License No. 06-20971-01  
Docket No. 030-22168  
Control 143747  
Eastern Connecticut State University

Dr. Colurso,

This refers to your letter dated May 18, 2009, with your survey results and the amendment dated May 18, 2009. Additional information is needed for the following:

Figure 4. Goddard Hall  
 First Floor  
 Drawing scale approximately 1" = 16'

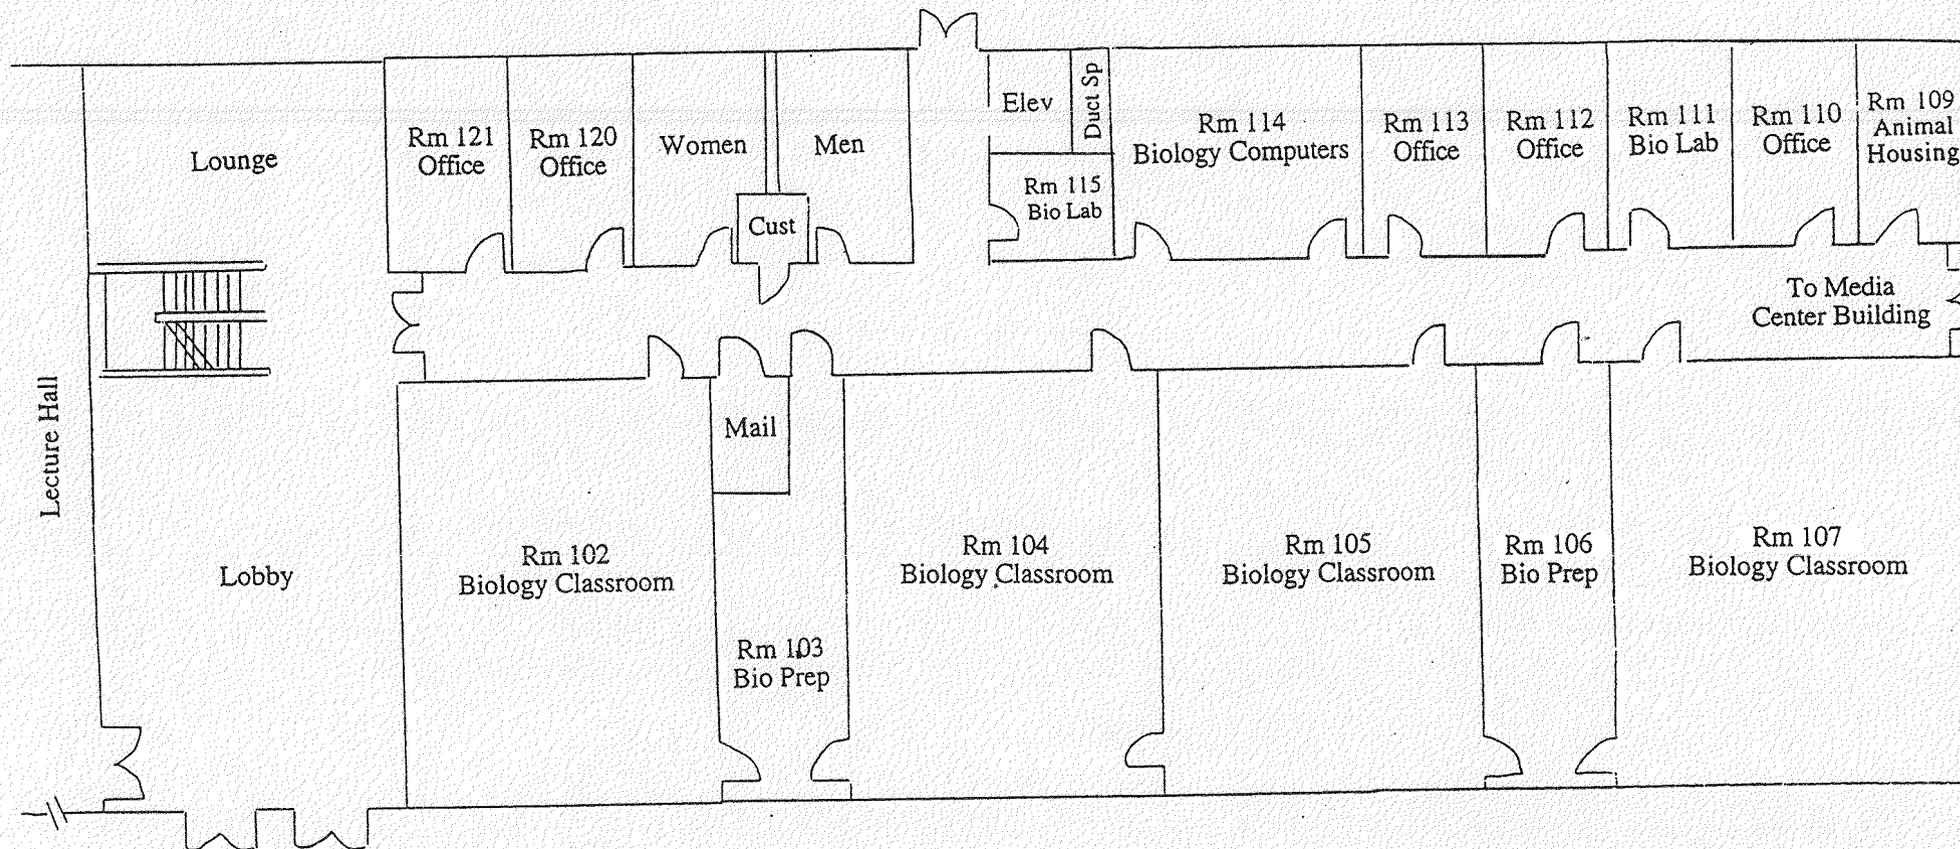
2. Based on the survey results you submitted, it appears that the areas used included rooms G107, M220, M218, M219, M220A, M220B, M222, G208 and G220. Confirm if these were the only rooms in which licensed activities were performed under the license. Briefly describe the estimated area (such as square footage) of these rooms and the total area of the building in which they are located, with a brief description of the building. Please describe the type of area in which the building is located (for example: rural, industrial, residential, etcetera).

*RESPONSE: Our previous license included the rooms listed above, except for G208. This room was the physics stockroom where magnets and radioactive discs were stored. All these items were below regulatory limits and were not part of our campus license. I surveyed that room before we moved to the new science building just to be safe. Additional surveys and scans of G208 are included with this response for the same reason.*

*One other room G106 was also part of our previous license. Even though we did not use that room for licensed activity, I have completed the required surveys and scans. Results are attached.*

*I have indicated the area of each room on the survey sheets in units of square meters. Our rooms were located in two buildings: Goddard Hall and Media Center. Floorplans for each building are included to identify the relative location/area of the rooms in question. Both buildings are located on our campus, which is surrounded by residential neighborhoods. A campus map is enclosed for clarity.*
